Review of the Bipole III EIS - Wildlife

Douglas L. Skinner, M.Sc., P.Biol.

Impact Definitions

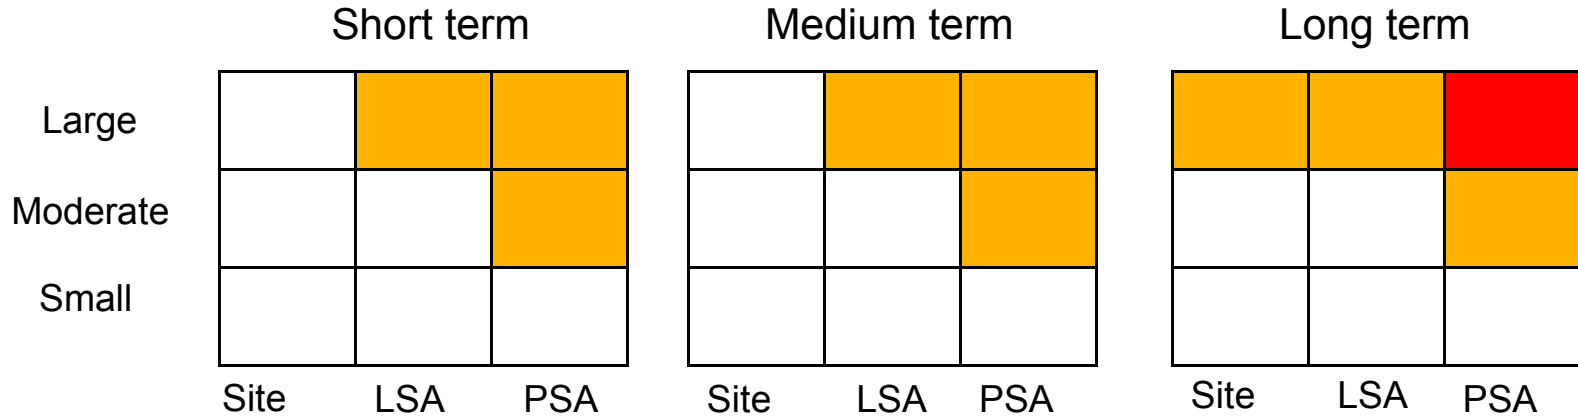
Concerns

Important Points

- Probability of a *significant* impact = 4% (1/27)
- Probability of a *potentially significant* impact = 33% (9/27)
- Probability of a *not significant* impact = 63% (17/27)
- Only long-term impacts (>50 yr) are *significant*
